**SP-15-00368:** A site plan for the redevelopment of properties located at 900 S. Iowa Street and 914 S. Iowa Street from an existing *Gas Fueling Station* (gas-convenience store with detached car wash) and a *Fast Order Food* use to a *Cleaning (car washing)* use. Submitted by Paul Werner Architects for Zaroco Inc/L& L Properties LLC, property owner of record.

**ADMINISTRATIVE DETERMINATION:** The Planning Director approves the above-described Site Plan subject to the following conditions:

**Figure 1: Perimeter parking lot area adjacent to W. 9<sup>th</sup> Terrace.**

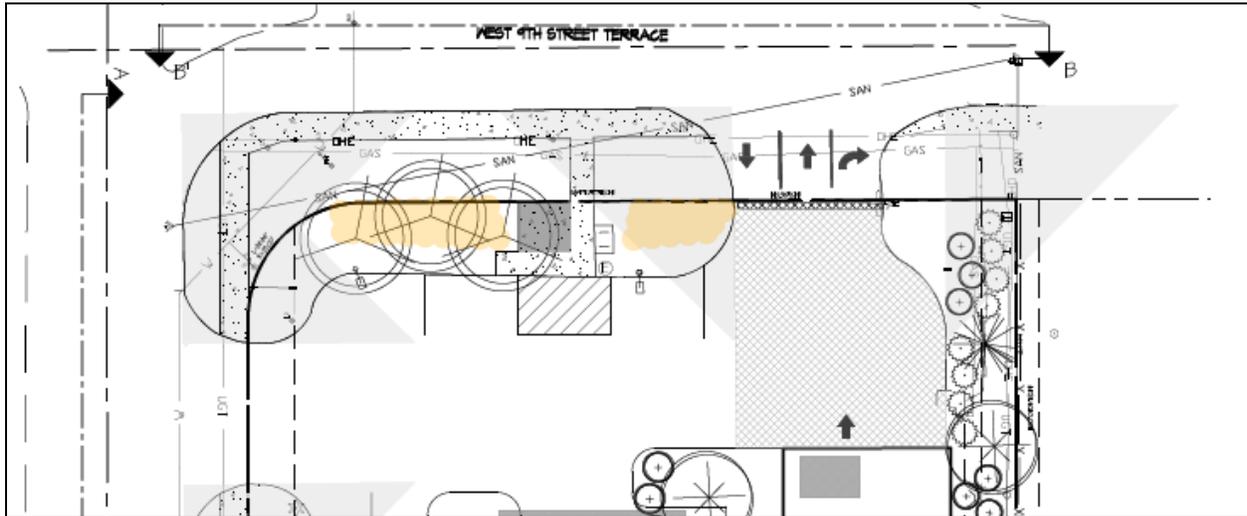
*Perimeter:* This standard applies to parking areas that abut public streets. The four (4) spaces located at the north end of the site are parallel spaces and subject to the design standard. The site

plan shows only street trees along W. 9<sup>th</sup> Terrace. Staff recommends that shrubs be added to provide screening of the parking spaces.

The parking space, in this location, designated for the food truck includes a sidewalk and picnic area as well as a bicycle parking pad that would not allow for screening of that portion of the parking lot.

**Figure 2: South Bufferyard CS to RSO.**

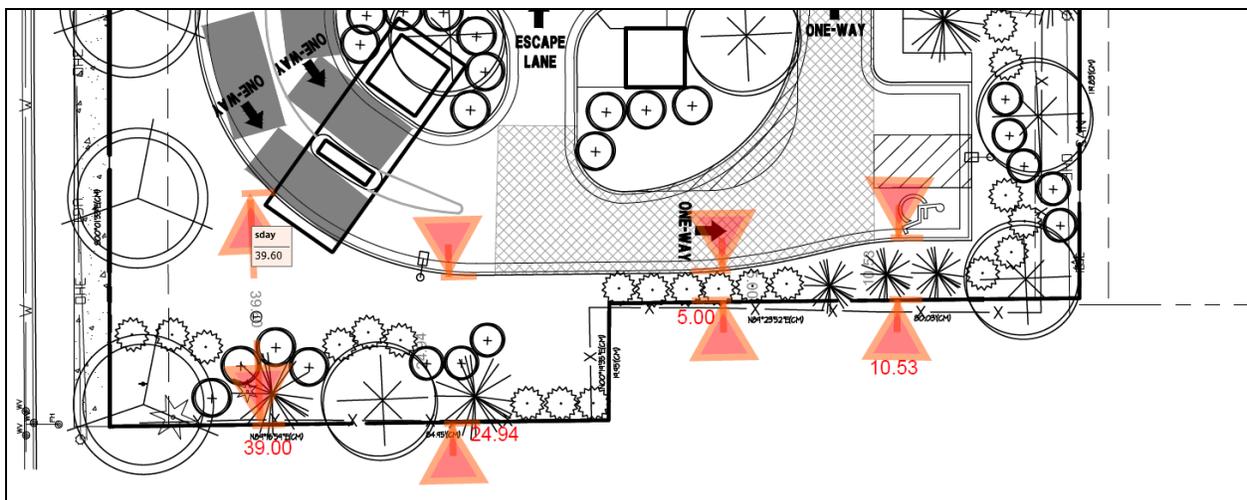
The area along the south property line is zoned for residential-office use and also requires a Type 2 Bufferyard (RSO District). The adjacent use is *office*. The proposed bufferyard along the south side ranges from more than 37' wide to as little as 5' wide. The estimated average width is approximate

19'. The current bufferyard is only 5'-10' wide along the south property line. This area also includes a fence as well as dense landscape. The narrow portion of the bufferyard is adjacent to an existing parking lot area and follows the existing curb line in this location to accommodate turning movements of vehicles. The minimum width of a Type 2 Bufferyard is 15'. Staff calculated the required trees and shrubs for both a 15' wide and a 20' wide Type 2 Bufferyard.

The design as proposed includes a short segment of area that is less than the minimum required width for a Type 2 bufferyard.

The applicant has not requested alternative compliance with this application. Staff recommends the landscape plan be revised to add additional landscape along the south property line to meet minimum design standards. Specifically,
